AGREEMENT

WHEREAS, the CRA desires to retain the services of the Contractor to provide the goods and services in accordance with the CRA’s Invitation to Bid No. 2022-01-R, and the Contractor’s response thereto, all of which are incorporated herein by reference.

A-620

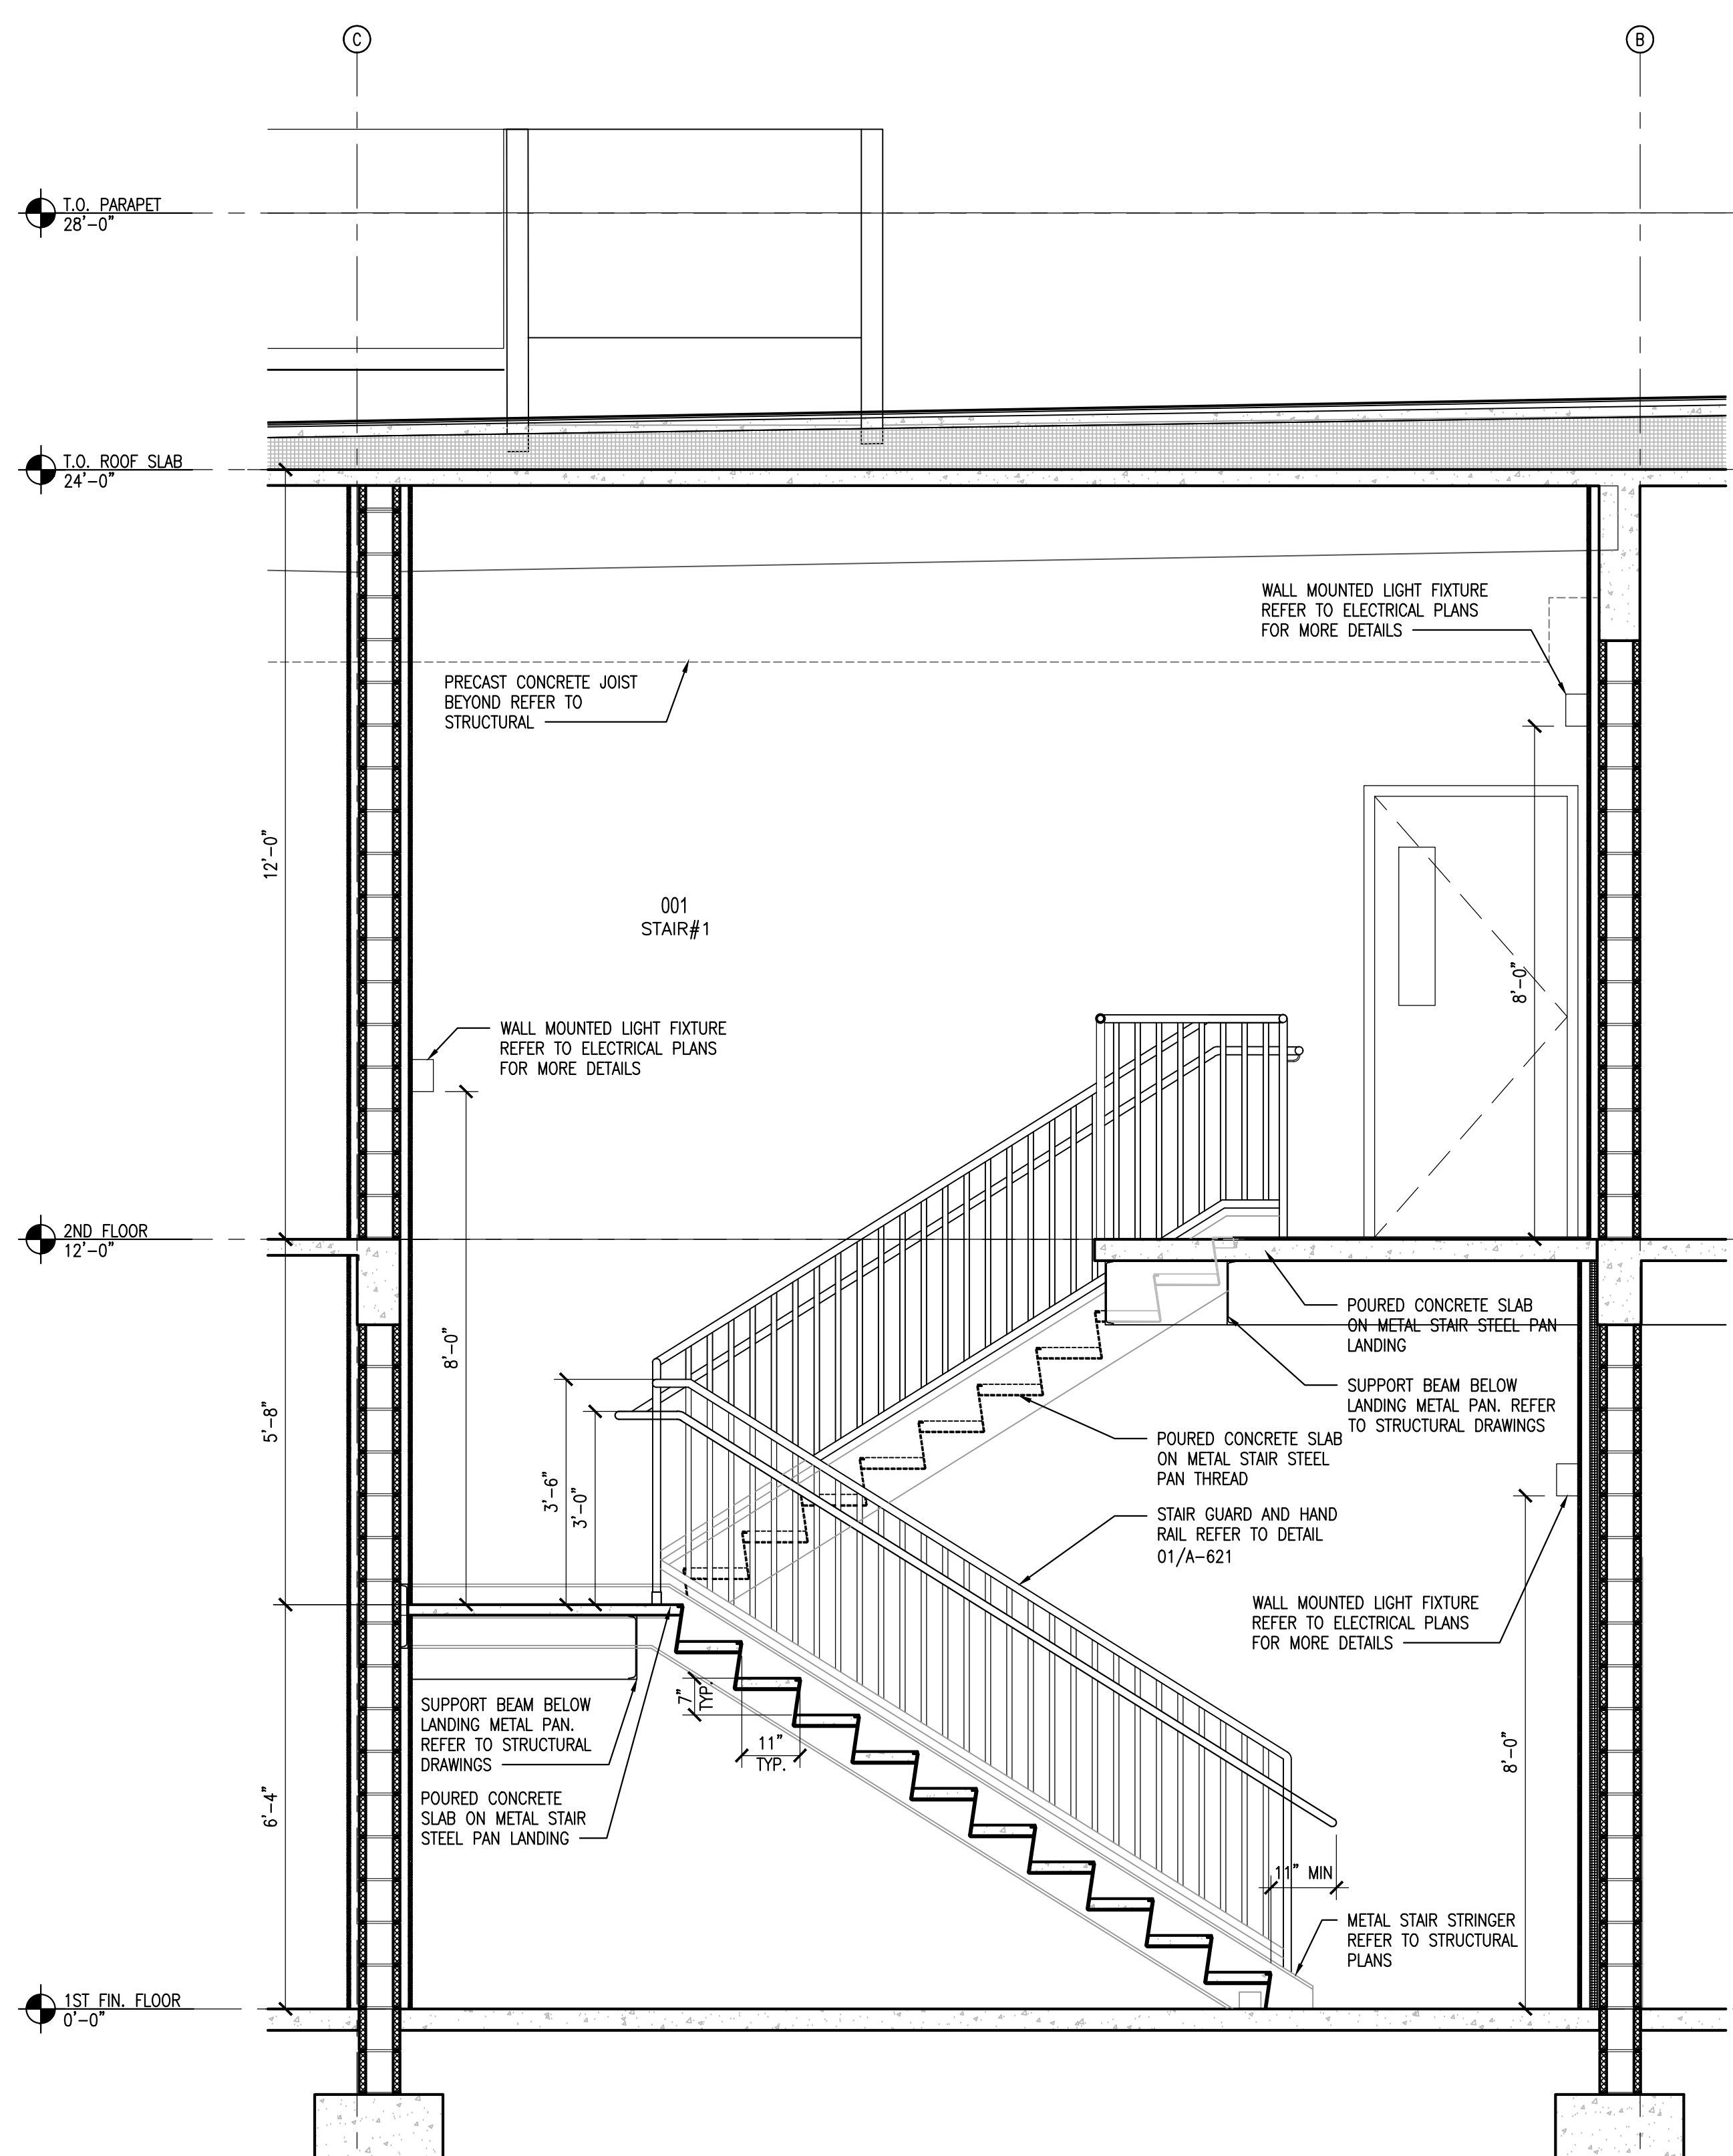
15. **There is no support beam at the 2nd floor stair landing (sheet S.20), but a support beam shows on (sheet A-620). Please clarify.**

Sheet A-620 shows part of metal pan stair. The metal pan stair and landing are pre-engineered. Please refer to specification section #05 51 00 for details on the metal pan stairs (page 108 of the Specification file).
